SUBJECT: ISSUANCE OF AMENDMENT NO. 36 TO FACILITY OPERATING LICENSE NPF-68
AND AMENDMENT NO. 16 TO FACILITY OPERATING LICENSE NPF-81 - VOGTLE
ELECTRIC GENERATING PLANT, UNITS 1 AND 2 (TACS 71564/71565)

The amendments revise TS 3.4.9, "Pressure/Temperature Limits," and the associated
bases concerning the number of effective full power years (EFPY) for which the
Vogtle Unit 1 heatup and cooldown curves are applicable. The applicability of
the Vogtle Unit 1 curves decreased from 16 EFPY to 13 EFPY based on an analysis
performed by Westinghouse Electric Corporation in response to Generic Letter 88-11.

SAFETY EVALUATION BY THE OFFICE OF NUCLEAR REACTOR REGULATION
RELATED TO AMENDMENT NO. 36 TO FACILITY OPERATING LICENSE NPF-68
AND AMENDMENT NO. 16 TO FACILITY OPERATING LICENSE NPF-81

VOGTLE ELECTRIC GENERATING PLANT, UNITS 1 AND 2

FIGURE 3.4-2a

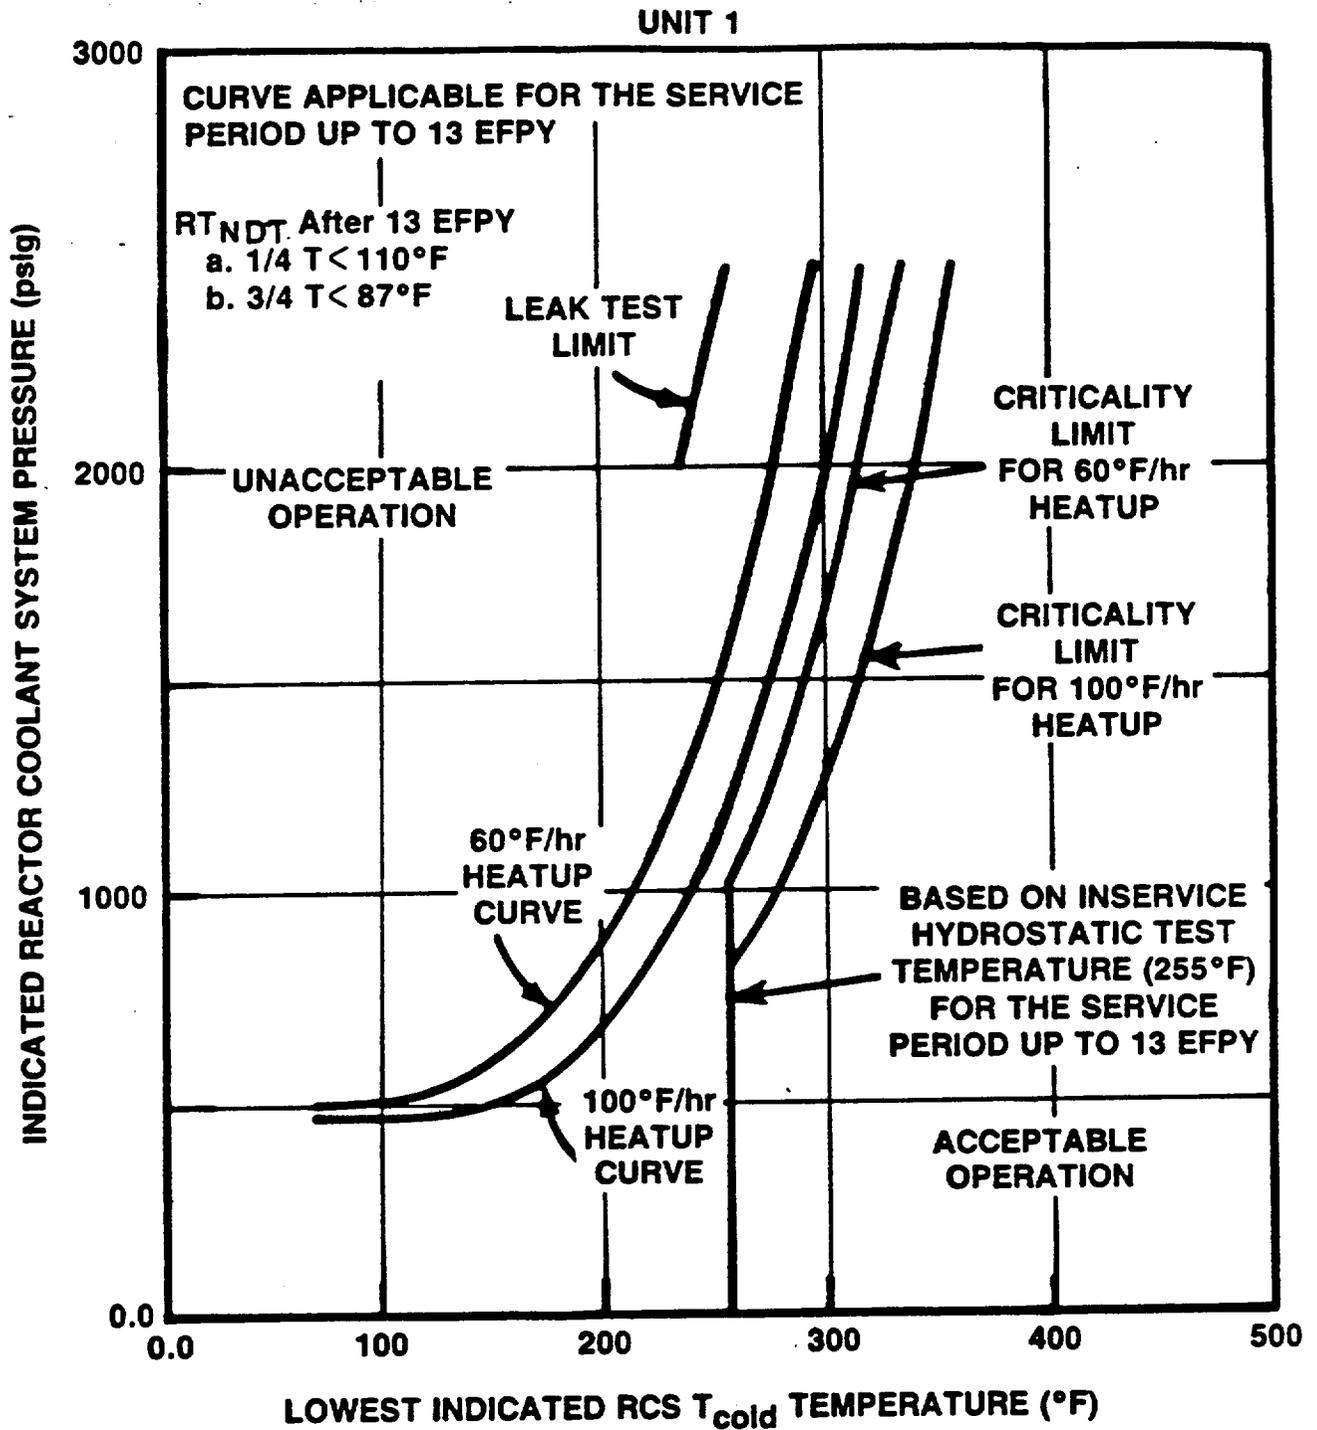
RT_{NDT} After 13 EFY @ $1/4 T < 110^{\circ}F$
 @ $3/4 T < 87^{\circ}F$

UNIT 1 REACTOR COOLANT SYSTEM HEATUP LIMITATIONS - APPLICABLE UP TO 13 EFY

The heatup and cooldown limit curves shown in Figures 3.4-2a and 3.4-3a are applicable to Unit 1 for up to 13 EFPY and are based on Westinghouse-developed generic curves which were developed assuming a 40°F initial RT_{NDT} and a copper content of 0.10 WT% for the most limiting material. These curves are applicable to Unit 1 since its most limiting material (Table B 3/4.4-1a) has both a lower initial RT_{NDT} (30°F) and a lower copper content (0.06 WT%).

The licensee used the method in RG 1.99, Rev. 2, to calculate an ART of 110°F at 1/4T and 87°F at 3/4T for the limiting material for 13 EFPY in Vogtle 1. Because the licensee's ART of 110°F is more conservative than the staff's ART of 101.2°F, the staff judges that the difference of about 9°F is acceptable. Substituting the ART of 110°F into equations in SRP 5.3.2, the staff verified that the proposed Vogtle 1 P/T limits for heatup, cooldown, and hydrotest meet the beltline material requirements in Appendix G of 10 CFR Part 50.

FIGURE 3.4-3a

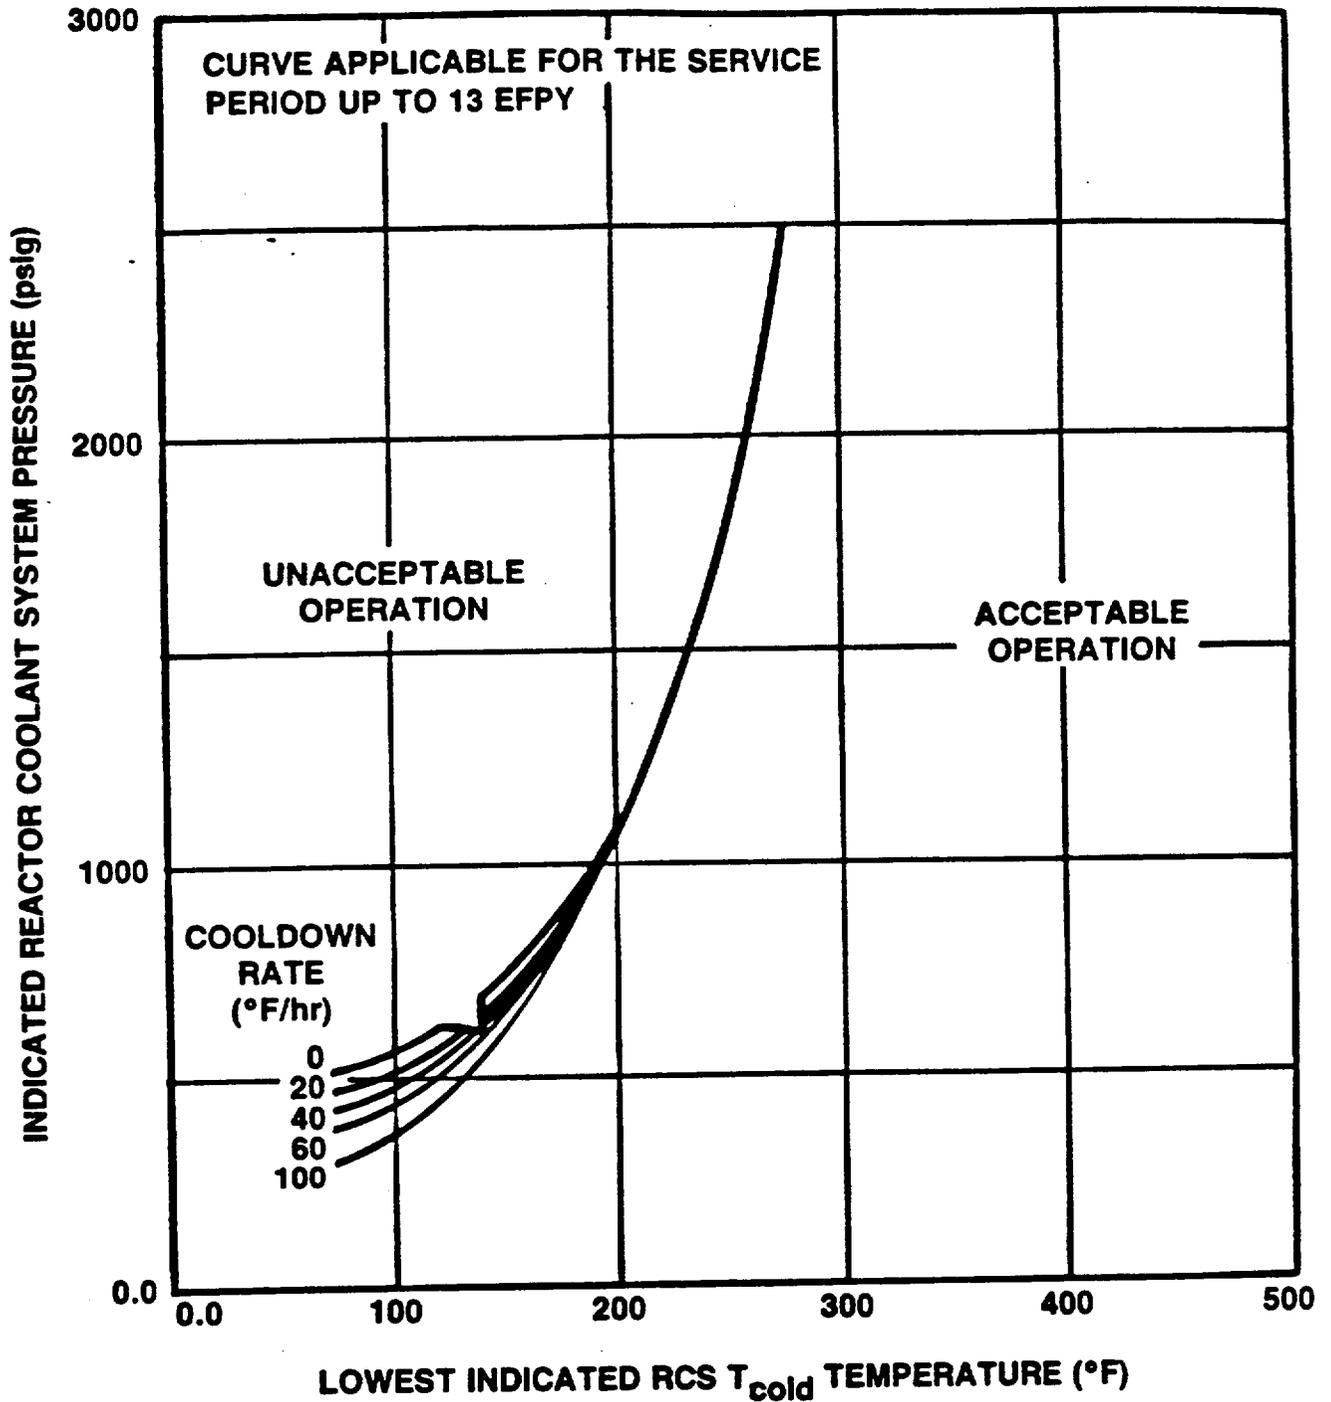
Copper Content: Assumed - 0.10 Wt %
 (Actual - 0.06 Wt %)
 RT_{NDT} Initial: Assumed - 40°F
 (Actual - 30°F)
 RT_{NDT} After 13 EFPY @ 1/4 T < 110°F
 @ 3/4 T < 87°F

UNIT 1 REACTOR COOLANT SYSTEM COOLDOWN LIMITATIONS - APPLICABLE UP TO 13 EFPY
